Spartan Fire, LLC

Technical Service Bulletin
TSB26-560-001

APPLIES TO: This service bulletin applies to certain model year 2025-2026 Gladiator and Metro Star, 2025-2026 FC-94, 2025-2026 KME Panther, and 2025 KME Predator model emergency response chassis cabs built between September 2025 and December 2025.

Figure 2.1

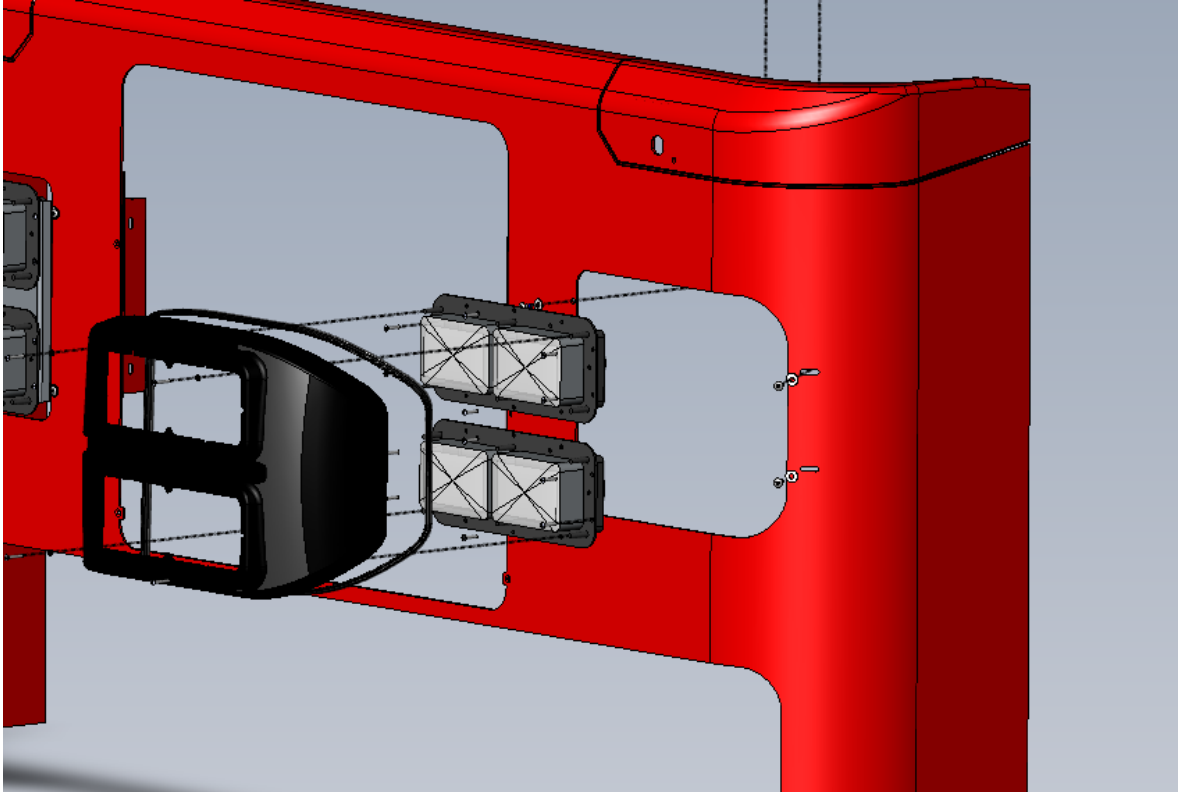
- 1) Remove left front headlight bezel and headlight bucket assembly. (See Figure 2.1)

Figure 3.1

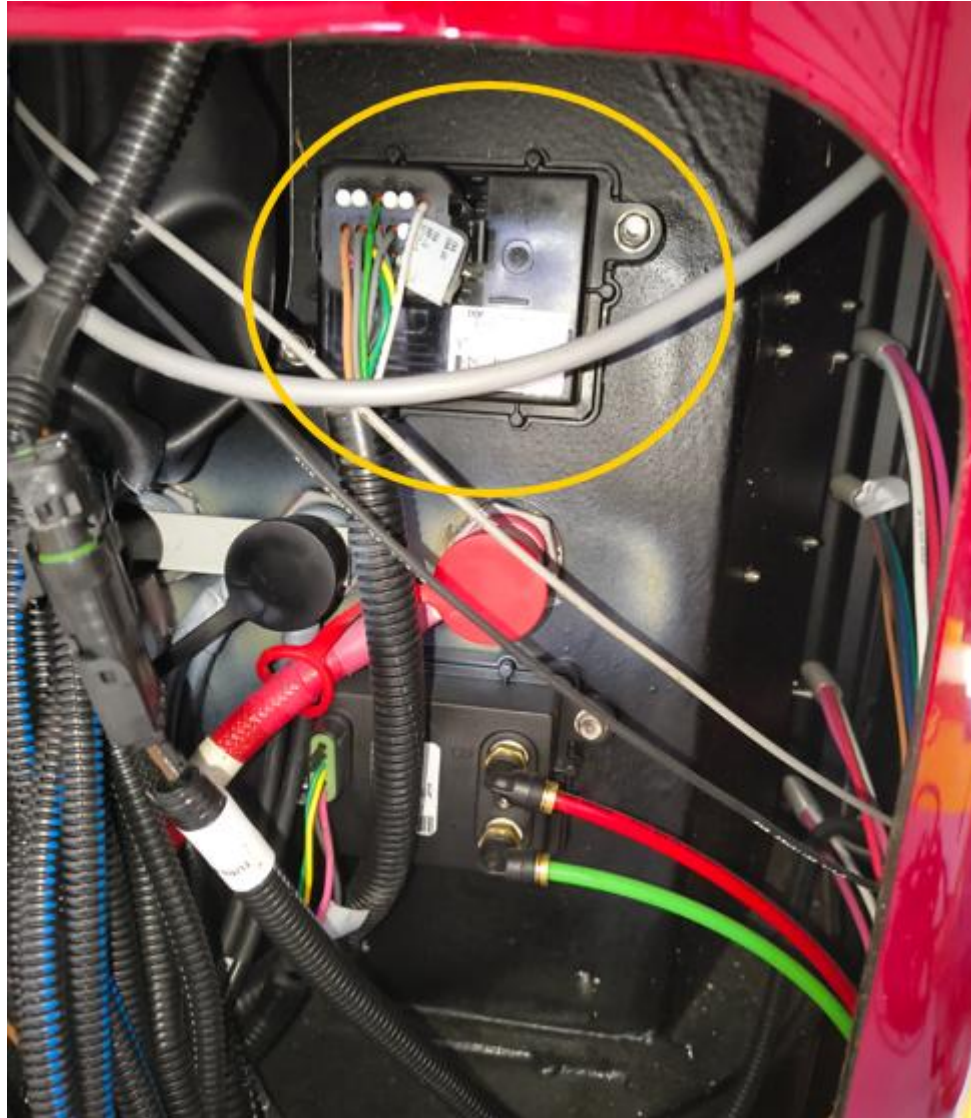
- 2) Locate the CAN I/O module behind the headlight bucket assembly. It can be properly identified as the module that does **not** have air lines connected to it. (See Figure 3.1)
